Addendum 47 – Regulation No. 48

Revision 8 - Amendment 1

Supplement 3 to the 05 series of amendments – Date of entry into force: 15 July 2013

Uniform provisions concerning the approval of vehicles with regard to the installation of lighting and light-signalling devices

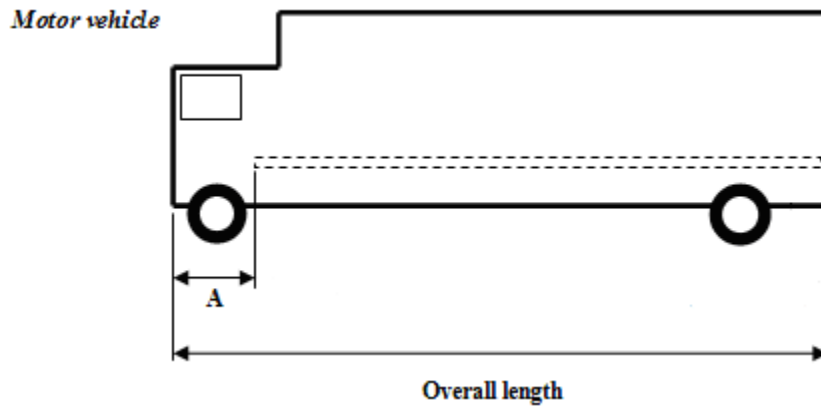
- 6.21.4.2.1.1. For motor vehicles, each end of the vehicle, or in the case of tractors for semi-trailers each end of the cab;

However, an alternative marking mode within 2,400 mm from the front end of the motor vehicle is allowed where a series of retro-reflectors of Class IVA of Regulation No. 3 or Class C of Regulation No. 104 are mounted followed by the required conspicuity marking as follows:

- (a) Retro-reflector size minimum 25 cm²;
- (b) One retro-reflector mounted not more than 600 mm from the front end of the vehicle;
- (c) Additional retro-reflectors spaced not more than 600 mm apart;
- (d) The distance between the last retro-reflector and the start of the conspicuity marking shall not exceed 600 mm;

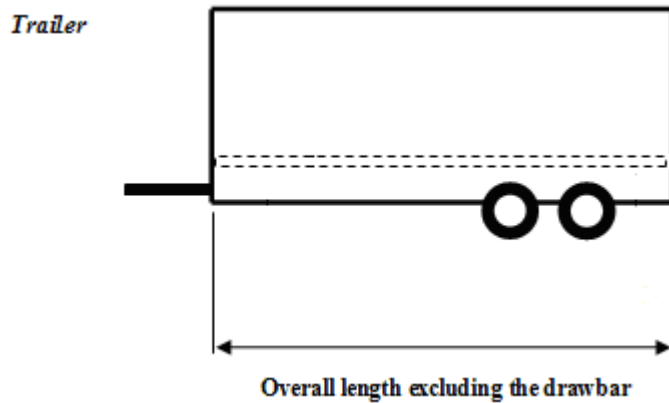
- 6.21.4.2.2.1. For motor vehicles, length of vehicle, or in the case of tractors for semi-trailers, if fitted, the length of the cab; however, when using the alternative marking mode per paragraph 6.21.4.2.1.1., the distance beginning within 2,400 mm from the front end of vehicle to its rear end.

A is the distance between the foremost conspicuity marking and the front end of the vehicle. The maximum value of A is 2,400 mm (see paragraph 6.21.4.2.1.1.)."
